## **MONTLIMAR PLAZA SUBDIVISION, UNIT TWO,** **RESUBDIVISION OF LOT 11**

APPLICATION NUMBER 13 DATE September 2, 2004

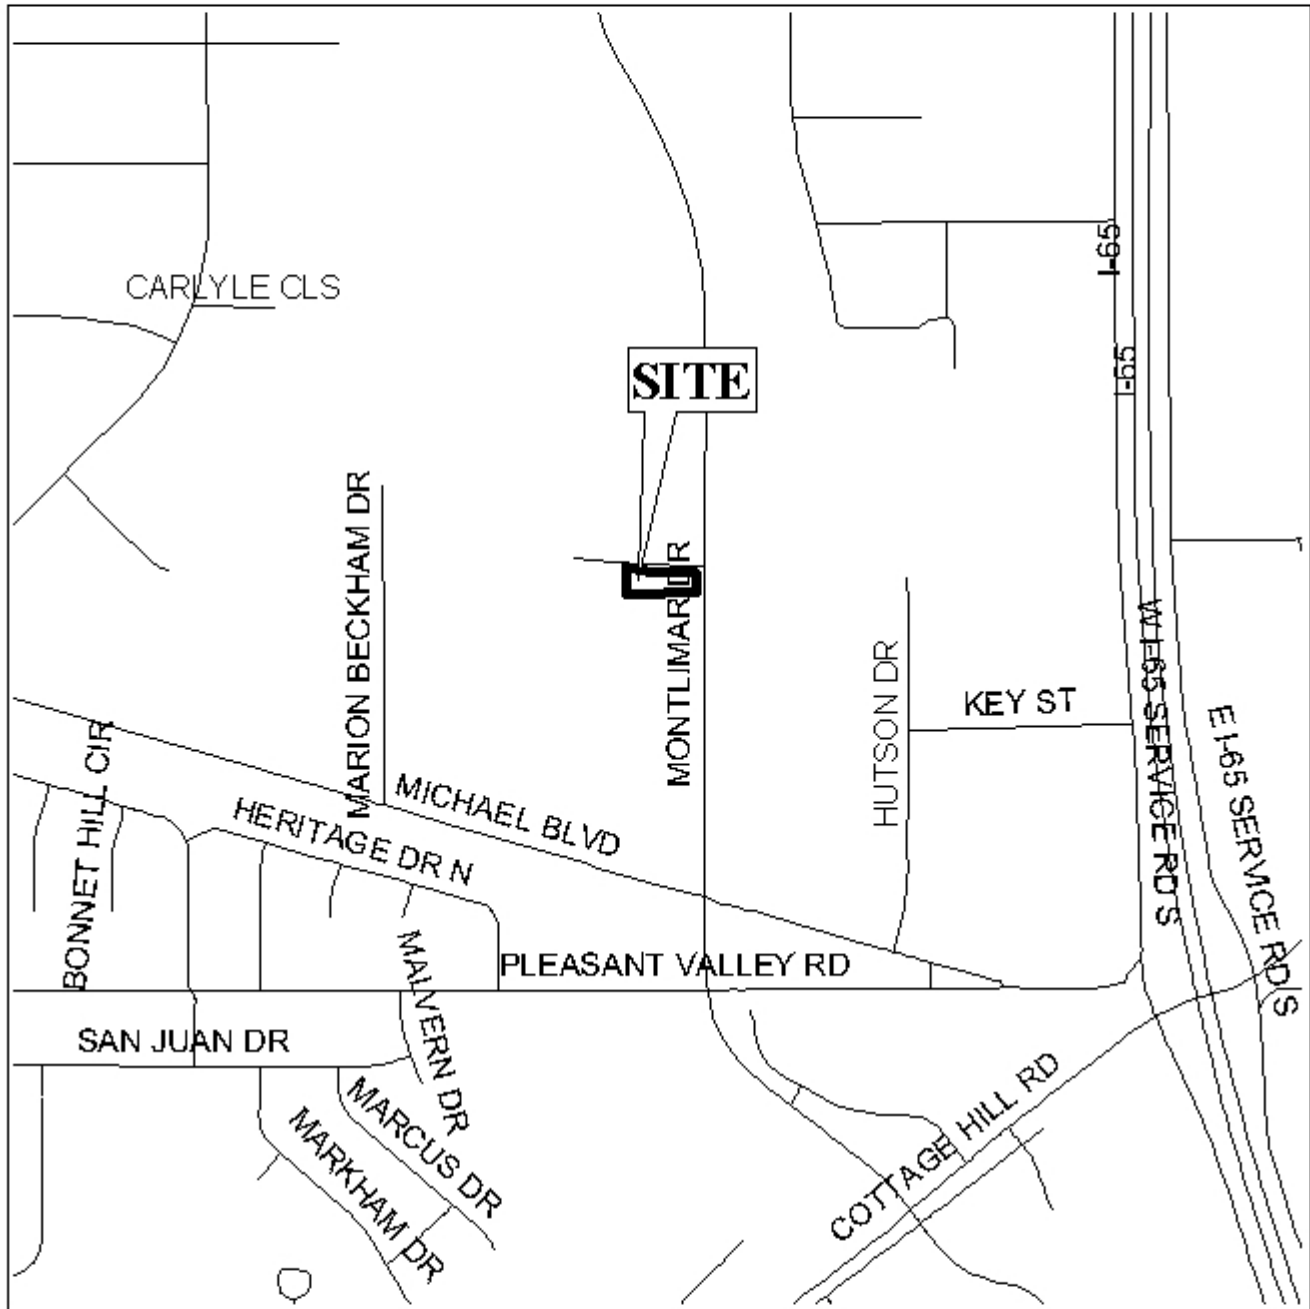
The plat illustrates the proposed 2 lot, 0.7  $\pm$  acre subdivision which is located at the Southwest corner of Montlimar Drive Montlimar Plaza Drive and is in City Council District 5. The subdivision is served by public water and sanitary sewer.

The site fronts Montlimar Drive, which is a heavily traveled five-lane street; therefore, as a means of access management, a note should be placed on the final plat stating that Lot 11-A is denied direct access to Montlimar Drive.

The plat meets the minimum requirements of the Subdivision Regulations and is recommended for Tentative Approval subject to the following condition: 1) the placement of a note on the final plat stating that Lot 11-A is denied direct access to Montlimar Drive.
